AMENDMENT OF SOLICITATION/MODIFICATION OF CONTRACT			1. CONTRACT ID CODE See Block #2	PAGE OF PAGES 1 of 20
2. AMENDMENT/MODIFICATION NO. N66001-02-R-5017	3. EFFECTIVE DATE 5 JUN 2002	4. REQUISITION/PURCHASE REQ.NO.		5. PROJECT NO. (If applicable)

**AMENDMENT 0001****FOR QUESTIONS AND ANSWERS (Q&A'S) AND ADMINISTRATIVE CHANGES**

Regarding SSC-SD RFP N66001-02-R-5017, entitled "Secure Digital Communication Control System."

FIGURE 1. Slope front enclosure console.

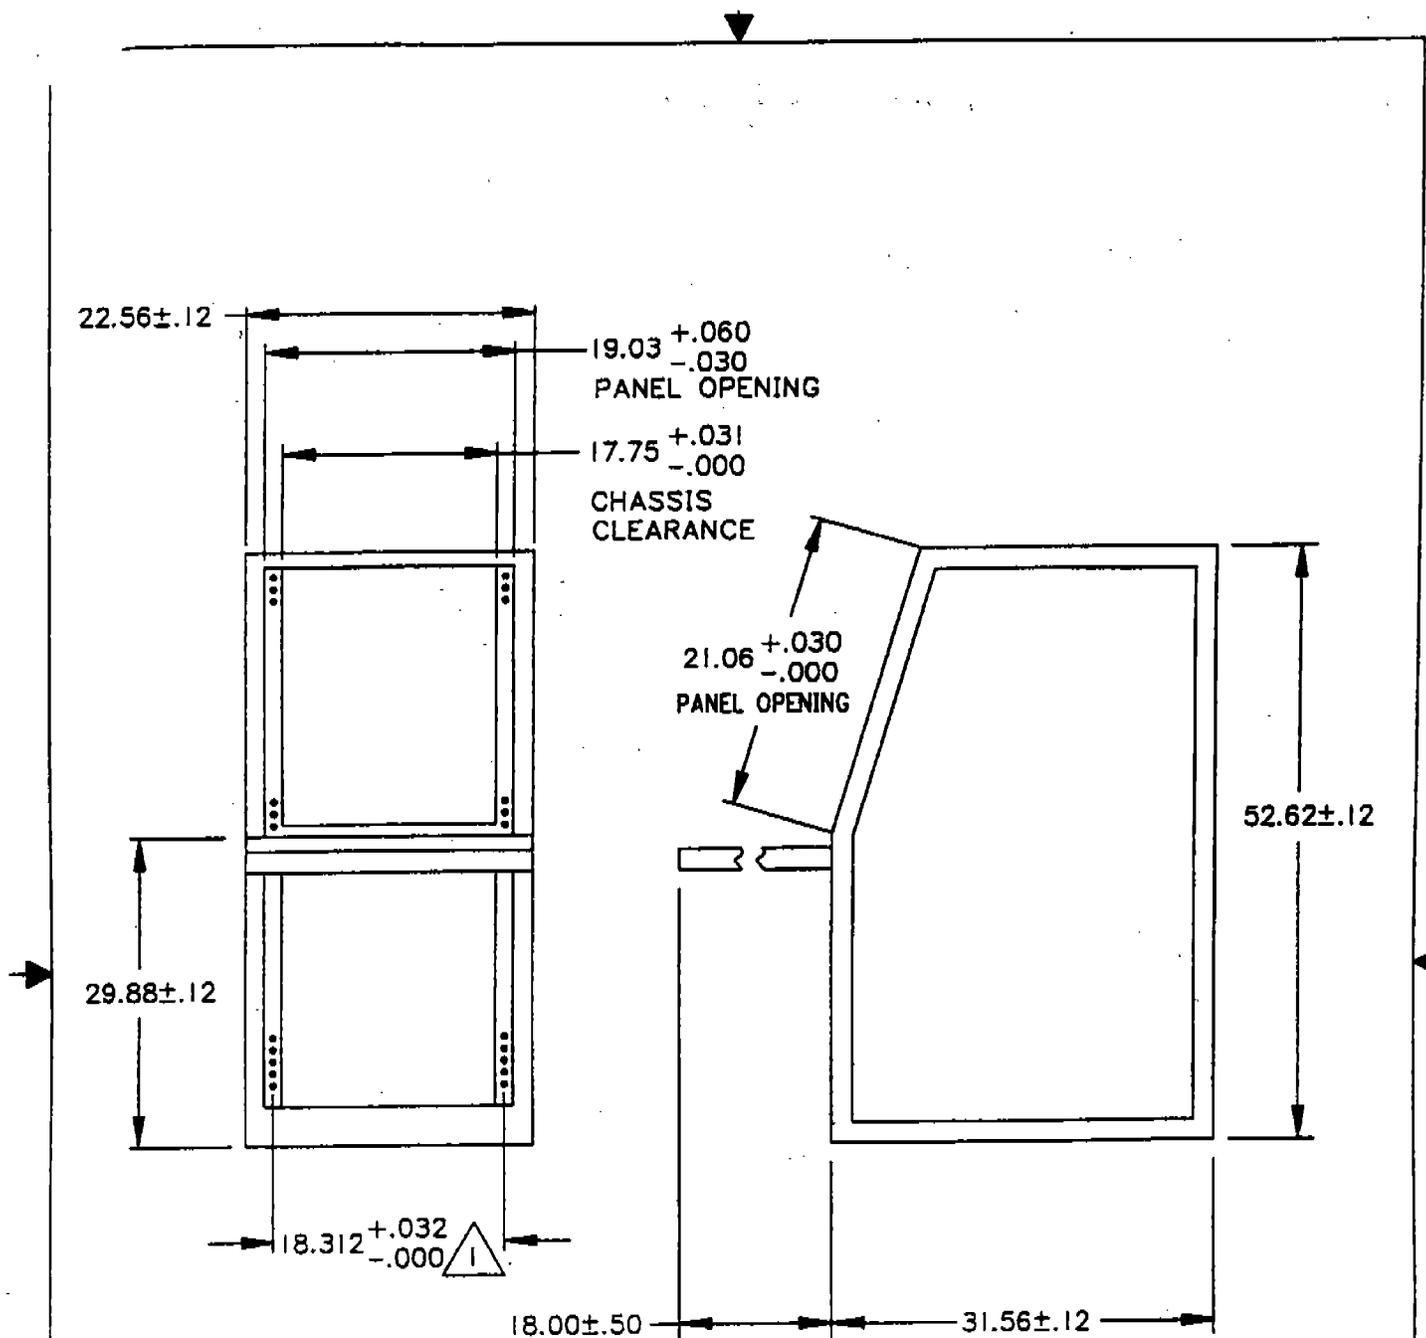
4. What is the vertical height and depth for the Type II 19 inch rack mounted Operator Station?

**Government Response:** See the Type II 19 inch rack drawing located on the SPAWAR website.

MTRACS DISPLAY CONSOLE,  
ASSEMBLY DRAWING

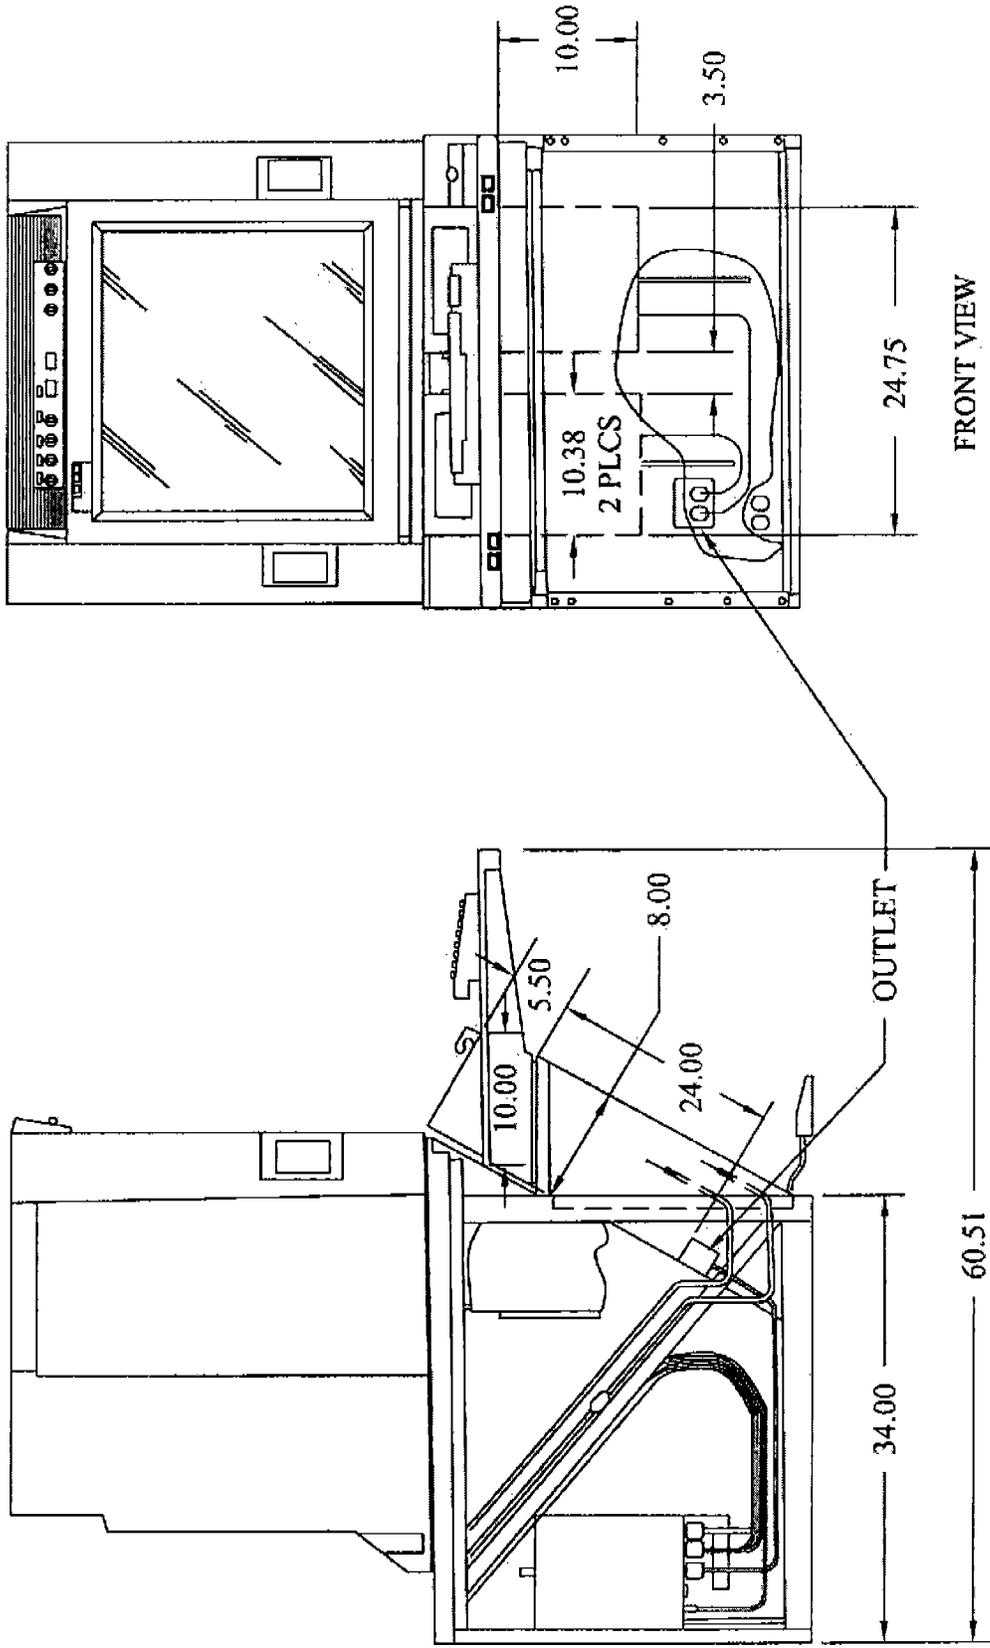
2. Are the mounting dimensions for the Type I Operator Station 8" high, 10.38" wide, and 24+5.5" deep?

**Government Response:** See the MTRACS Display Console, Assembly Drawing located on the SPAWAR website.
